ORIGINATION FORM

Proposed Revisions to a Standard Plans Index
(Please provide all information — Incomplete forms will be returned)

Index Number: 430-001
Sheet Number (s): 4 of 7
Index Title: Miscellaneous Drainage Details

Sheet 4: Moved "Joining Mainline Pipe to Stub Pipe Details" and Notes 2 and 3 to the Standard Plans Instructions:
Deleted Notes 5-7.

INDEX SHEET
430-001 4 of 7

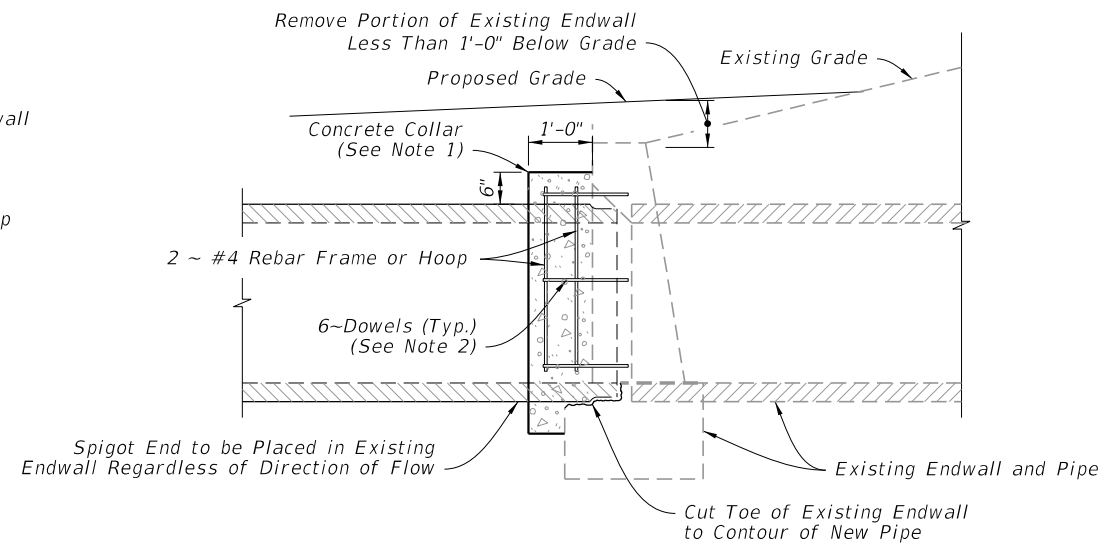
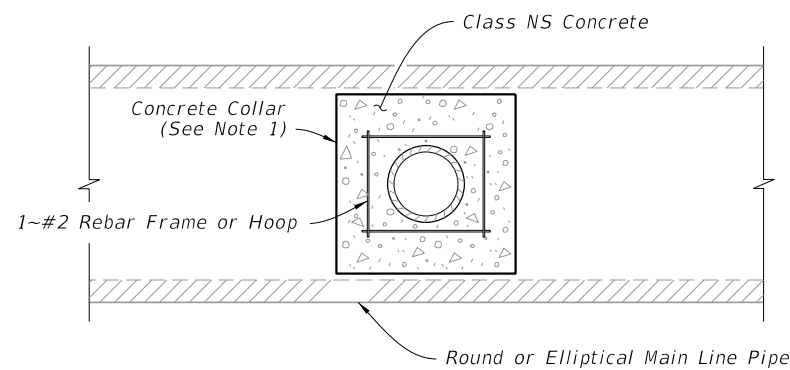
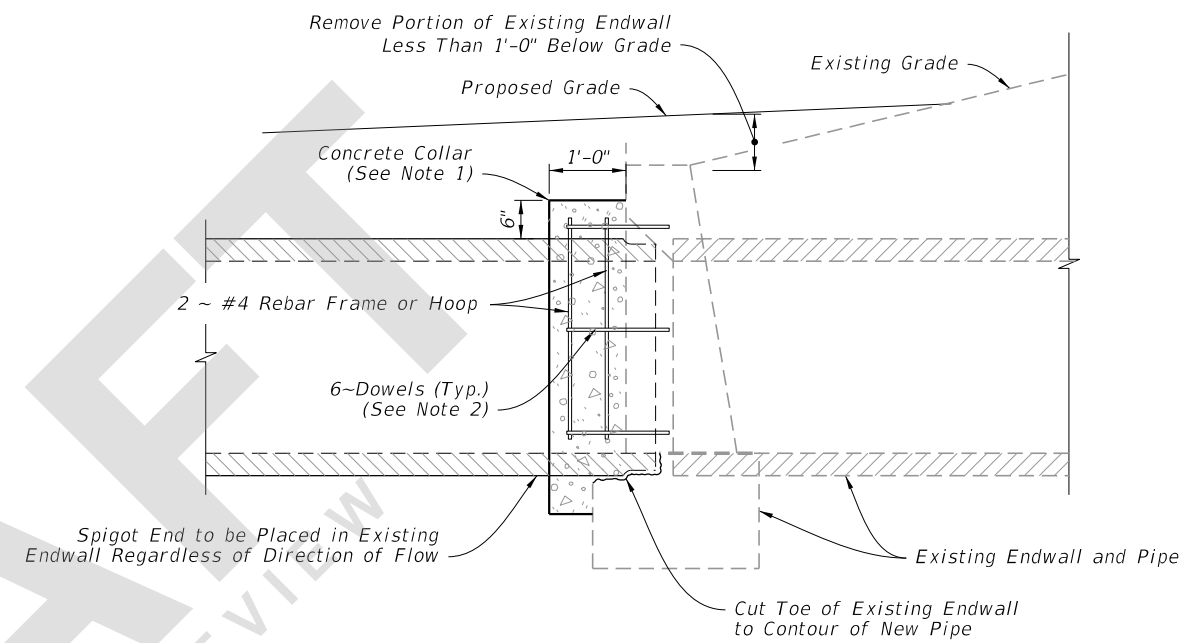
- ~~✗~~ Install riser reinforcement using #5 Bars @ 18" centers vertically and 6" centers horizontally. Bend pipe steel to riser.
- ~~✗~~ Reinforced concrete top required when inlet: manhole or junction box riser is less than 4 feet in diameter; or when 3'-6", alt. b inlet, manhole or junction box riser is used; or when rectangular inlet is used.
- ~~✗~~ See Index 425-001 for optional construction joints.

DELETED

JOINING MAINLINE PIPE TO STUB PIPE

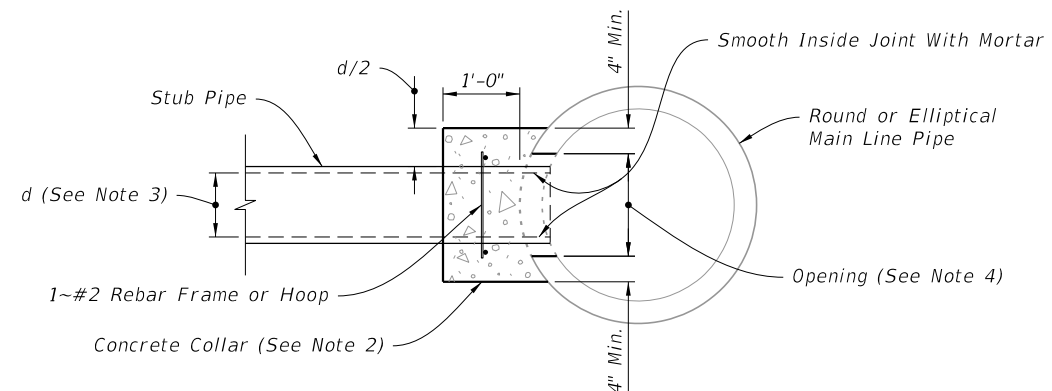
The Drainage Manual requires pipe junctions to have topside access via a structure. Deviation from using a structure to join pipes requires District Drainage Engineer approval. While there are applications where the stub to mainline pipe may be needed, the detail is proposed to be removed from the Index to emphasize it as a non-standard item.

Moved to SPI
